Access Compliance Report

Public Rights-of-Way

(Curb Ramps)

Intersection ID: 28456	Main Street: SUMMER_CREEK_LN	Cross Street: BENFIELD_RD	Location: SW
ADA ID: 565A689D544C	Ramp Type: Directional1	Initial Pass/Fail: Fail	Overall Compliance: No
		Severity Score: 1.25

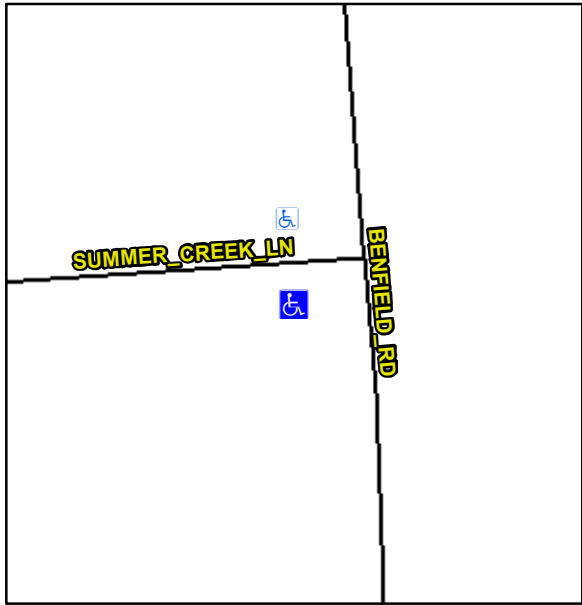
Codes/Mitigation Info/Possible Solution		Field Measurements/Component Compliance						
	Possible Solutions:		Compliance	Description	Data	Compliance	Description	Data
	Remove & Replace Entire Ramp.		N/A	Ramp Length (in)	74.0	N/A	Grade Break?	N/A
			Yes	Ramp Width (in)	72.0	N/A	Grade Break Slope (%)	0.0
			Yes	Ramp Slope (%)	6.6	N/A	Grade Break XSlope (%)	0.0
			No	Ramp XSlope (%)	3.0			
			N/A	Flare Type LT	N/A	N/A	Flare Type RT	N/A
			N/A	Flare Slope LT (%)	N/A	N/A	Flare Slope RT (%)	0.0
			N/A	Flare Traversable LT?	N/A	N/A	Flare Traversable RT?	N/A
			N/A	Landing Length (in)	0.0	N/A	DWS Provided?	N/A
			N/A	Landing Width (in)	0.0	N/A	DWS Contrast?	N/A
			N/A	Landing Slope (%)	0.0	N/A	DWS Length (in)	N/A
			N/A	Landing X Slope (%)	0.0	N/A	DWS Full Width?	N/A
			N/A	Landing Curb? (Y/N)	N/A	N/A	DWS Offset LT (in)	N/A
			N/A	Shared Landing?	N/A	N/A	DWS Offset RT (in)	N/A
			N/A	Gutter Ponding?	0.0	N/A	Gutter Slope (%)	N/A

N/A	Gutter Lip Ht (in)	0.0	N/A	Gutter X Slope (%)	N/A
			N/A	Painted X Walk1?	No		Road Slope (%)	5.0
				X Walk 1 Direction	To N		Road X Slope (%)	2.2
				X Walk 1 Width (in)	N/A		Clear Space?	N/A
				X Walk 1 Slope (%)	5.0	N/A	Clear Space to XWalk (in)	N/A
				X Walk 1 X Slope (%)	2.2	N/A	Storm Grate/Utility Hazard?	N/A
			N/A	Ramp inside XWalk1?	N/A		Storm Grate/Utility Type	
			N/A	Any Obstructions?	N/A			N/A
				Obstruction Type		Yes	Surface Condition? (G/P)	Good
						N/A	Curb Slope (%)	13.2
Total Cost:		\$	1600.00					
Street 1 Name		SUMMER CREEK LN						
Stop Condition-Street 1		StopSign						
Street 2 Name		N/A						
Stop Condition-Street 2		N/A						
PROW/ADA:		R304.5.3						
Surveyor Notes:		N/A
